File # 11-A-20-VA

BOARD OF ZONING APPEALS APPLICATION

1. Increase the maximum total height for freestanding cut off luminaire in a nonresidential district from 20 feet to 37 feet (Article 10.2.B.5).

BUILDING #2 SHELL PACKAGE FOR
HISTORIC MIDDLEBROOK PIKE
4281 MIDDLEBROOK FARM WAY, KNOXVILLE, TENNESSEE

SITE PHOTOMETRIC PLAN

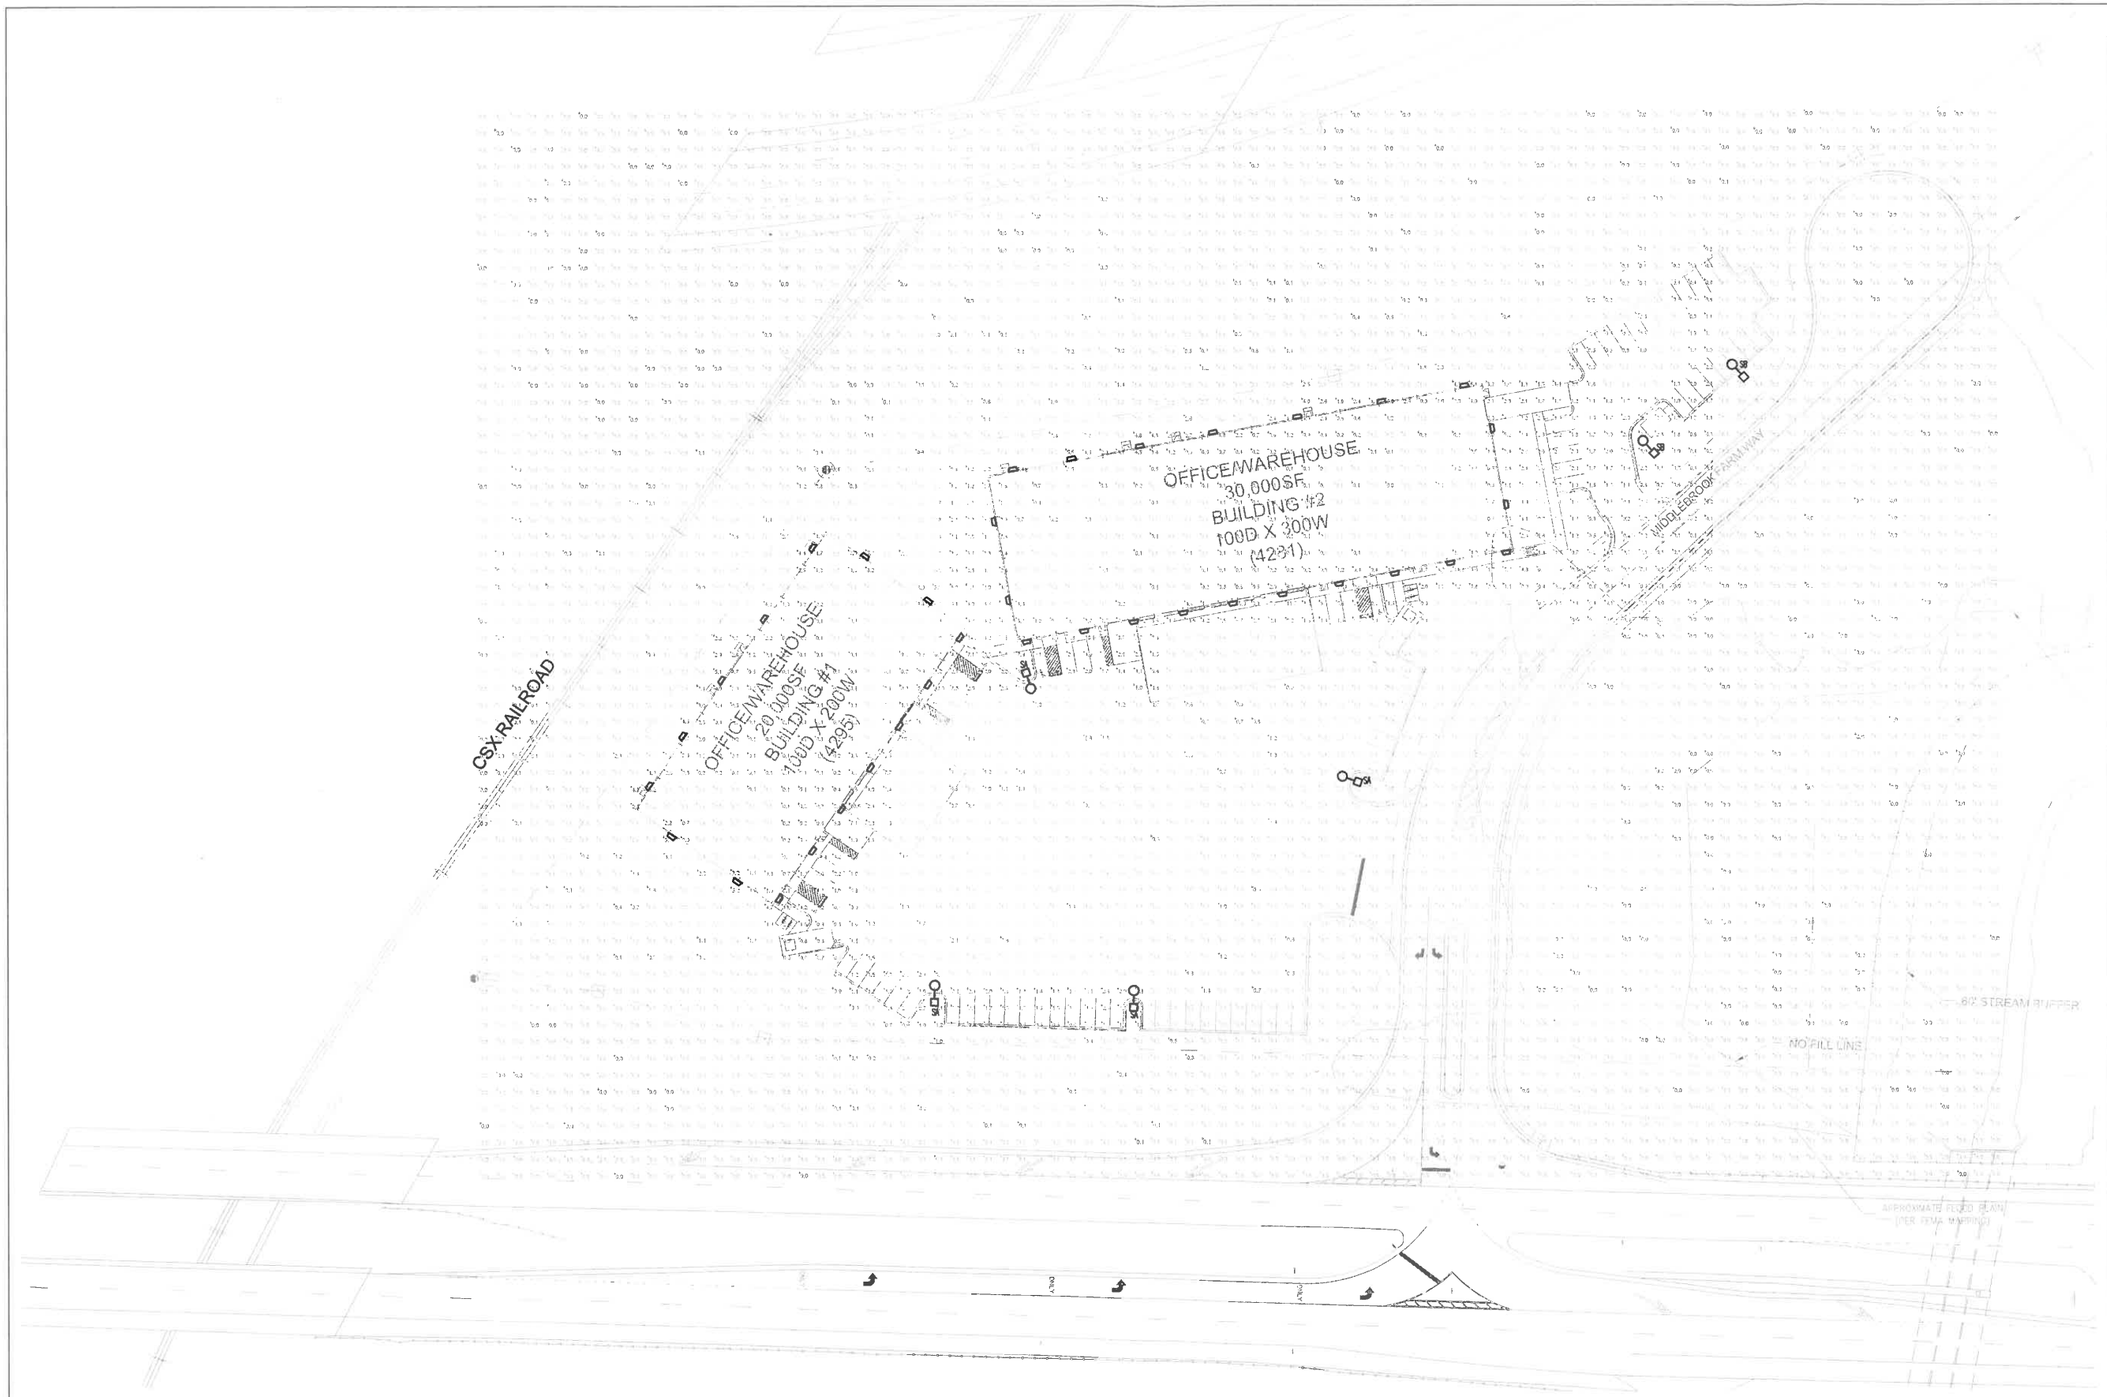
Thanks for the updated application and photometric plan. We can revise the application with both. However, if the cut-off angle of the light cannot meet the 75 degree required by the code I will have to have a measurement to vary it to. The variance is to be granted to the minimum adjustment necessary for reasonable use of the land. If this is not determined now then it will only come up again in plans review when you submit for construction.

See attached plan. The light fixtures do not meet the 75 degree requirement and they would have to be raised farther to light the center of the lot effectively. I have also updated the application to not the 75 degree cut off.

1) Specification for the light fixture showing the cutoff angle (anything more than 75-degrees requires variance).
2) Revised photometrics showing what the light numbers are behind the poles as the lights dissipates towards the property line.
